SUBJECT: Forwards response to NRC 840815 request for addl info re
 facility safety parameter display sys implementation plan in
 accordance w/Generic Ltr 82-33.

Re: TURKEY POINT UNITS 3 & 4
DOCKET NOS. 50-250 & 50-251
SPDS IMPLEMENTATION PLAN AND
PARAMETER SELECTION REPORT
REQUEST FOR ADDITIONAL INFORMATION

RESPONSE TO THE NRC QUESTIONS

Figure 1 Diagram of Online Monitoring of Isolators

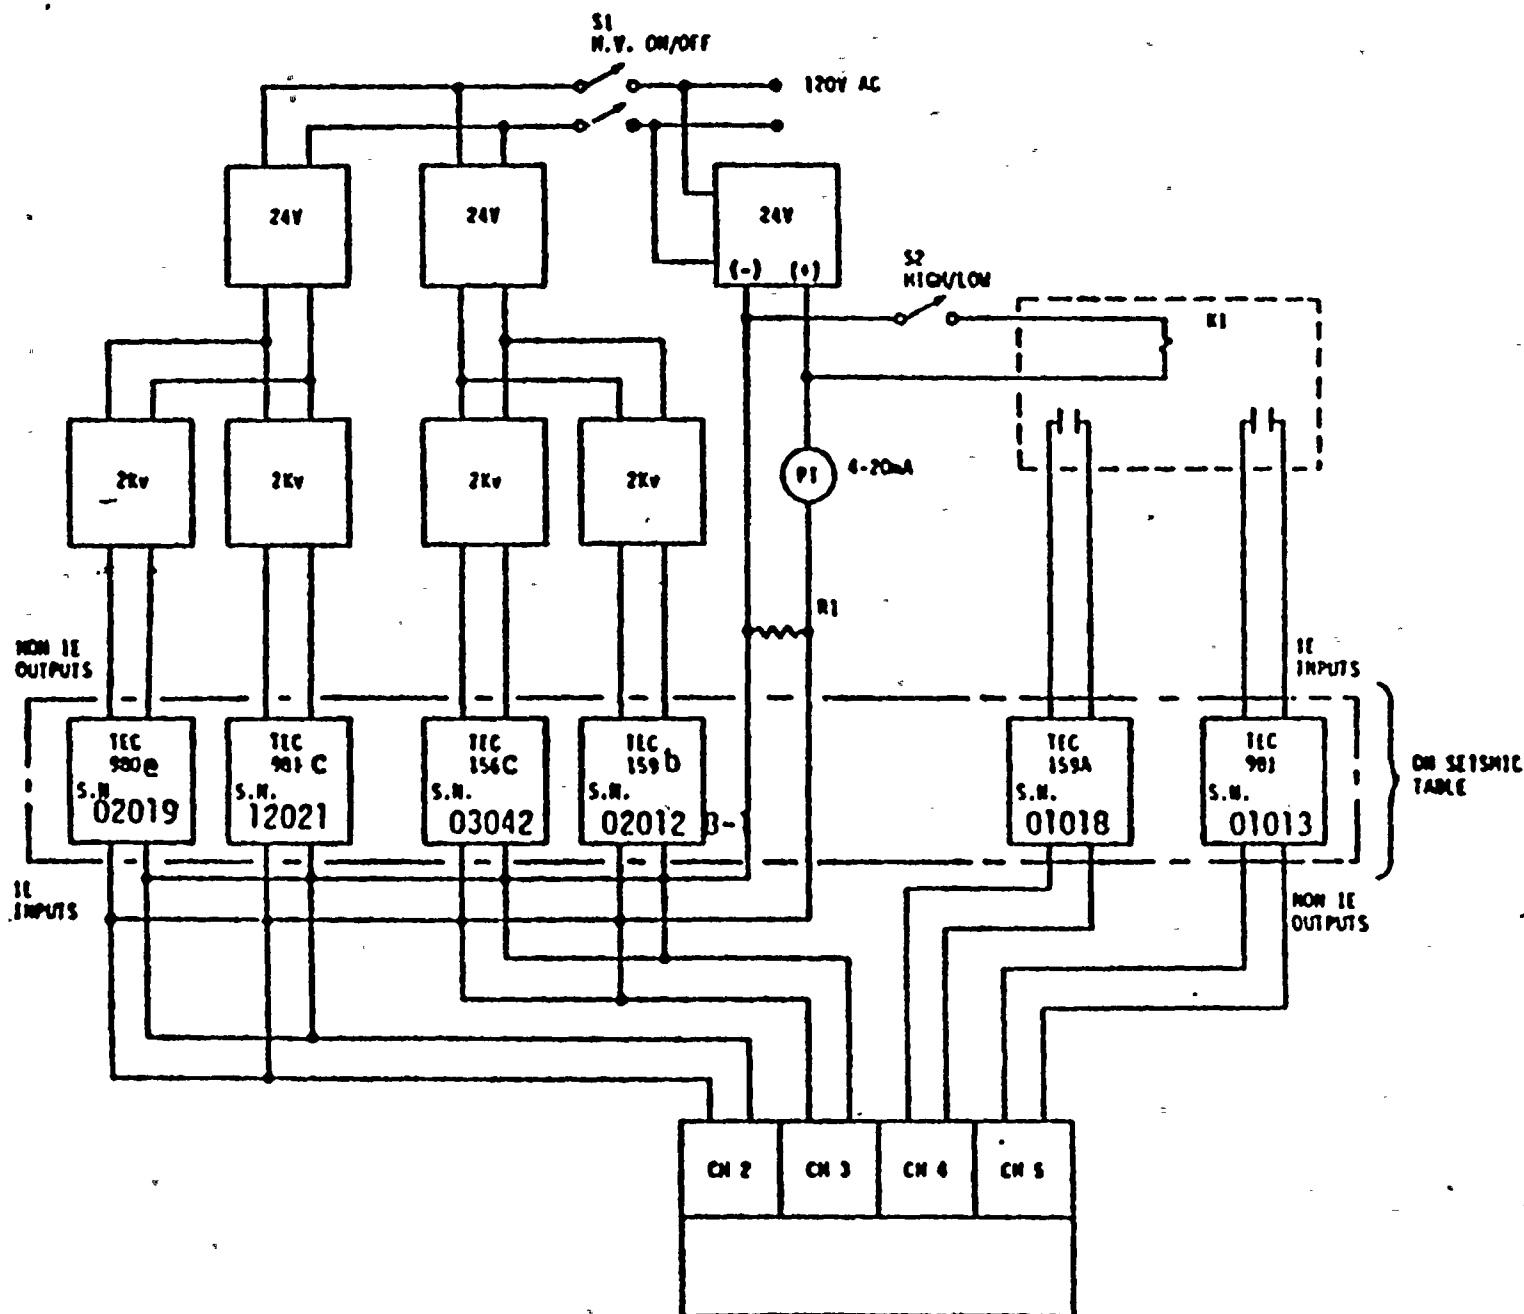
- a) The testing performed to demonstrate that the device was acceptable to accomplish electrical isolation was done using 2000 V dc. This voltage was applied across the non-IE outputs during the seismic test. The IE input side of the isolators (Figure 1) was monitored to see that no breakdown has occurred. Figure 2 shows the test configuration and the manner in which the maximum credible faults were applied. The model 981 digital isolators were functionally tested for high and low output during the second SSE. The output of the recorders during 2000 V dc test is shown in Fig. 3. The chart shows that there was no effect on the isolator.

- c) Figure 1 "Diagram of On-Line Monitoring of Isolators page 16 from TEC test report 30152-TR-02 and Figure 2 "Isolation Capabilities test of 2200 Isolation System" from TEC procedure number 30152-DVTP-01 show that the signals were applied to the TEC isolator devices in the transverse mode and open circuit mode. It is also apparent from the block diagram of the analog and digital isolators (Figures 4 & 5) that any short on the output side would not pass through the opto isolator in the digital 981 isolators or the demodulator section of the analog 980 isolators.

Figure 2

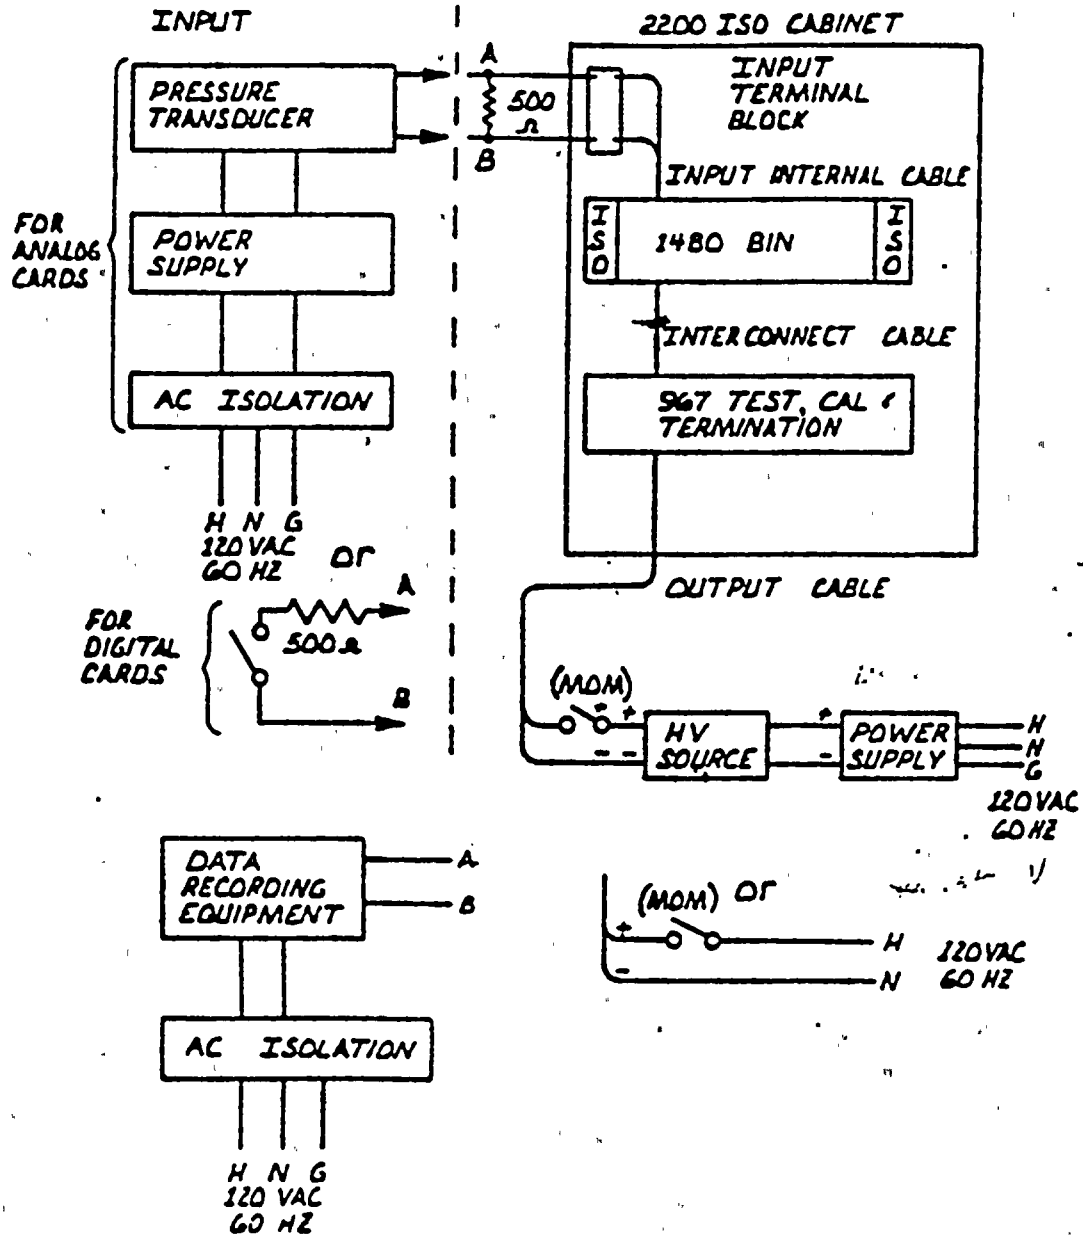
Digital isolators were also tested using the Fig. 2 arrangement by applying 2000 V dc. Once again there was no effect on the input or class IE side of the isolator noted.

under the cabinets. Therefore, the maximum credible voltage that can be applied to the output is the power supply output voltage of ± 15 Vdc. Figure 2 provides the data that 2000 V dc was applied to the non-IE side. This is far above the ± 15 V dc required. Since 2000 V dc was applied, the current flowing through the isolators is much greater than that at ± 15 Vdc.
